I am submitting the present letter and accompanying report of Arborist John Kipping in connection with the April 10, 2014 Tri-County Technical Advisory Committee's meeting as it relates to Village East, LLC's October 15, 2014 application for a zoning change.

Re: Kirkwood Park to Parking Lot Rezone Proposal

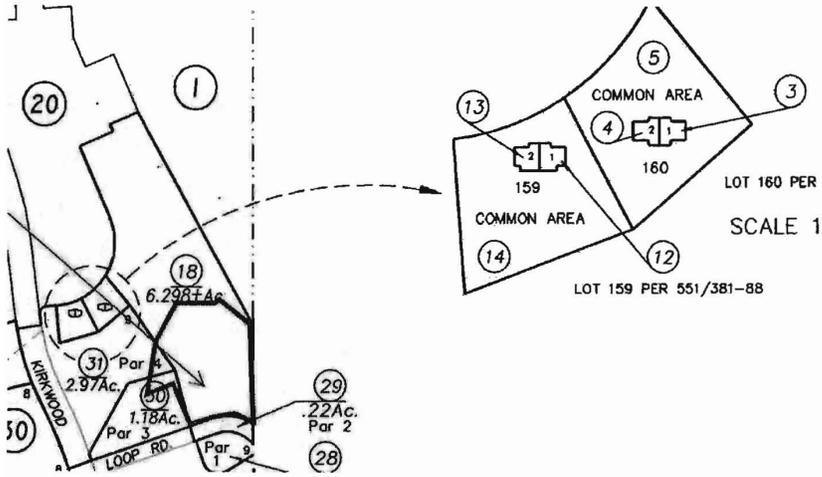
Using the land for the proposed parking lot will greatly change the contour. The entry of the parking lot is on Loop Road. The opposite ends of the proposed lots are many feet lower. The November 5, 2014 drawing of the lot I reviewed contains contour lines, but does not provide a contour interval or otherwise label the contours. (Exhibit 5.) Constructing the parking lot may entail the placement many hundreds of yards of fill, or many thousands. That there will be a substantial amount of fill can be gleaned by looking at the many closely spaced contour lines surrounding the "Existing Tree to Remain" symbol found between the two parking lots.

One thing the contour lines do show is that the proposed parking lot will lie at an oblique angle, thus giving residence of Alpine County and users of the meadow a broadside view of the asphalt.

The contour lines also show that cars are to be parked perpendicular to the fall line, which is not conducive to a parking lot covered with ice and snow. How often the cars slide into the side of each other when pulling in and out of the slots is any ones guess.

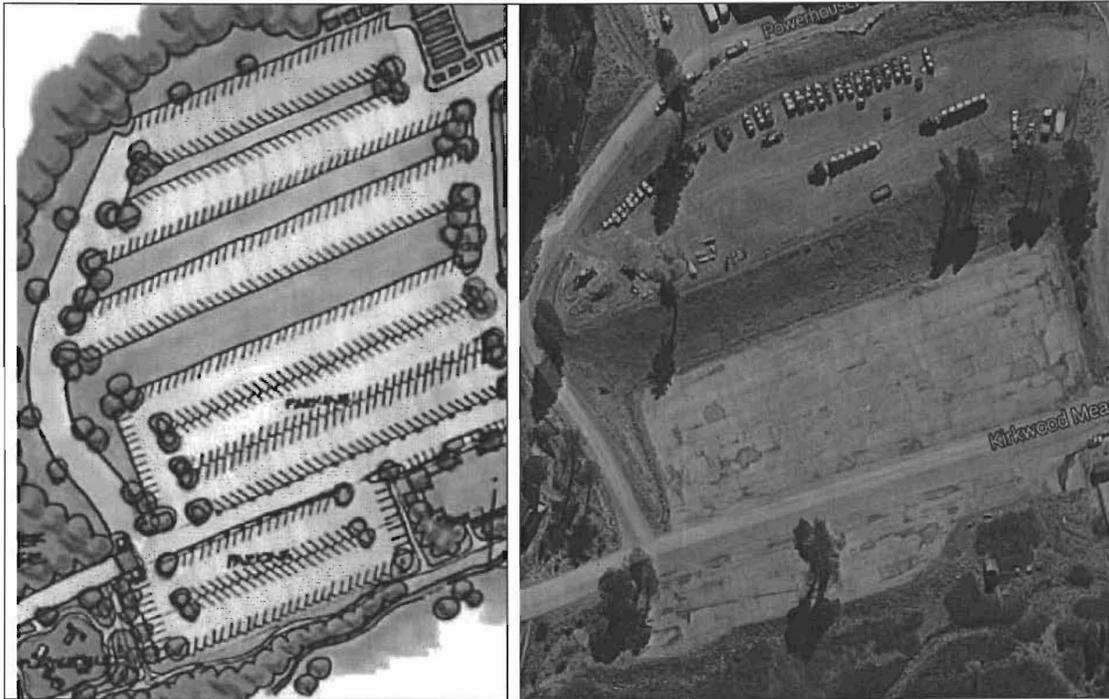
Given the presence of screening trees on the parking lot drawing, Kirkwood appears to recognize the parking lot will have a detrimental effect on scenic views, not only from the adjacent residences but also from the meadow and Alpine County. As discussed extensively in arborist John Kipping's report which accompanies this letter, any attempt to screen the parking lot and the propane tanks and other equipment on Loop Road would be futile. Not only would the screening trees not grow, the trees left in place may die, and even if they lived, would do little in the way of screening.

It is not difficult to draw screening trees on a plan, it is another thing to actually plant them and get them to grow. This is exemplified by Kirkwood's rendering of the Red Cliff's parking lot in the Specific Plan (below left) and a current aerial photo of the lot (below right). The only trees on or near the lot of any size are mature trees, and they have no branches on the first thirty feet or so of their trunks.

Photograph 3. KMPUD facility viewed through lodgepole pines from proposed parking lot.

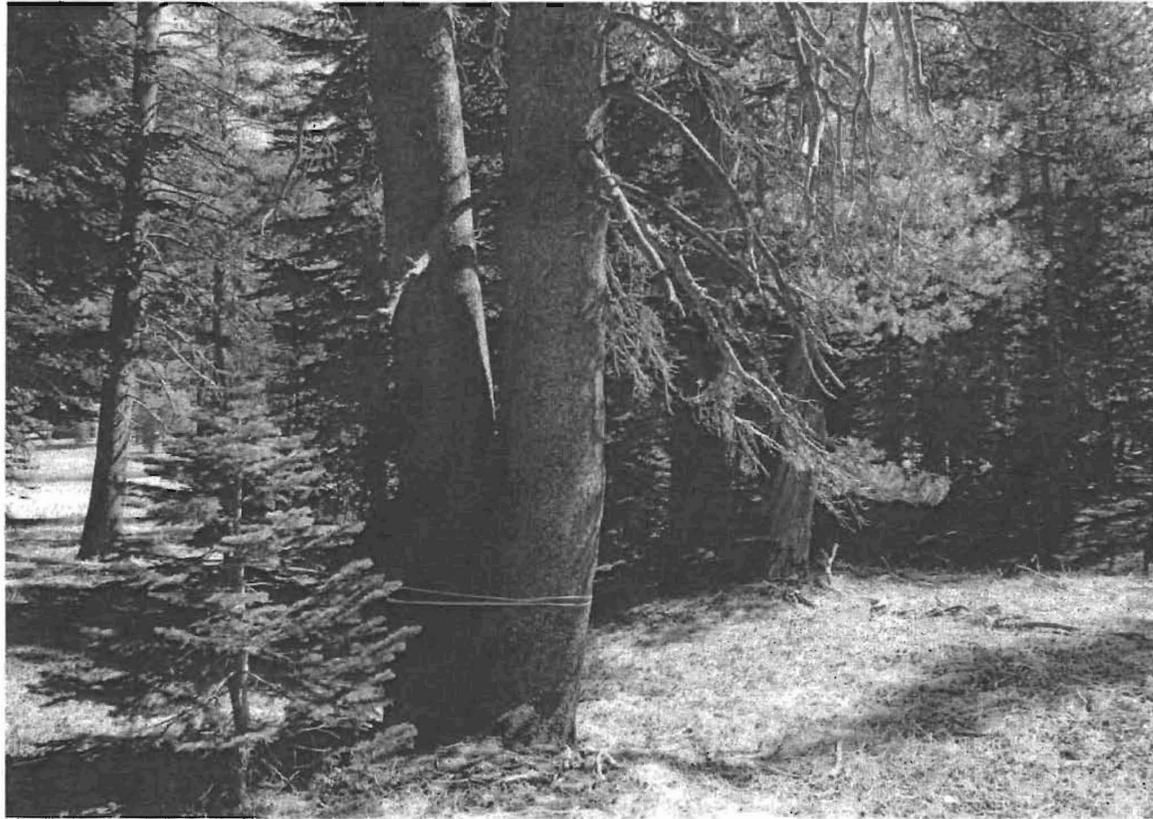
1. Although the Application for Zone Change to Amador County describes the site as "lightly treed," inferring that tree loss would be minimal, I observed numerous large red fir and lodgepole pines (see photographs 1 and 2). Most development plans show the locations, species, and sizes of all trees on site, but this proposal lists only four trees proposed for preservation, as well as two other old-growth trees to be removed. This lack of data makes total loss of canopy cover difficult to assess.

5. The applicant proposes to mitigate visual and sound impacts of this project by planting trees to replace the natural screen. Revegetation has been a difficult task at Kirkwood. KMPUD manager Michael Sharp showed me a group of spruce planted 15 years ago to replace screening lost during building construction. The trees shown in photograph 6 have faired poorly and have lost their tops in winter storms. Despite good care and one-and-a-half decades, they have not yet provided effective screening. Kirkwood resident Alan Sapp drove me to some buildings at Kirkwood that he had constructed more than a decade ago; his landscaping with new trees was not successful, despite professional care. The current drought makes mestablishment even more doubtful.
